Non-Substantial Change Summary Memorandum

RE: Phase 1 of the Addison Rutland Natural Gas Project
Non-Substantial Change Summary
Docket No. 7970

**Vermont Gas - ANGP Phase I
Chittenden and Addison
Counties, VT
MLV-1 Location Comparison Map**

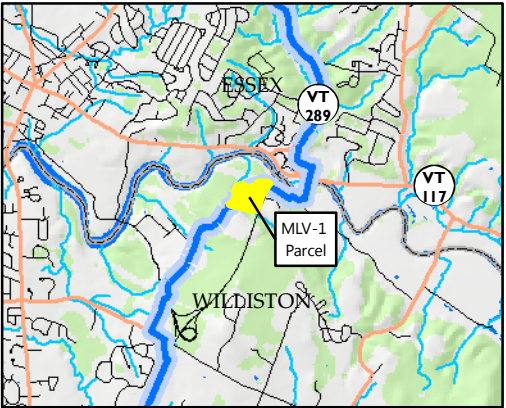
As an initial matter, the Project budget of approximately \$154 million, as filed with the Board on December 19, 2014, does not need to be modified for this Project Change. This change simply involves the relocation of MLV-1 to a different location on the same land parcel. As originally designed, MLV-1 was in close proximity to both Redmond Road and overhead GMP electric distribution lines. While there are no code restrictions preventing MLV-1 from being constructed where it was initially located, Vermont Gas has identified an alternate location for MLV-1 that we believe is better, as the valve would not be proximate to the electric lines and would be further from the road. By doing so, we remove a potential risk factor during construction as well as the on-going operation and maintenance of both the natural gas and electric systems. As noted above, MLV-1 is slated for construction during the 2015 construction season.

The attached orthographic map shows both the prior and now-proposed locations for MLV-1. See Attachment A. MLV-1 is being relocated approximately 1,000 feet to the east, north east of the location initially approved in the CPG. The now proposed MLV-1 location is located within an area generally containing existing commercial/industrial activities. No additional tree clearing or earth disturbance outside the previously permitted corridor will be required, and access to the MLV-1 site will be from Redmond Road, along the Project corridor, with no additional access roads required. Attachment B provides the revised Sheet EPSC-015 of the EPSC Plan reflecting the proposed MLV-1 location.
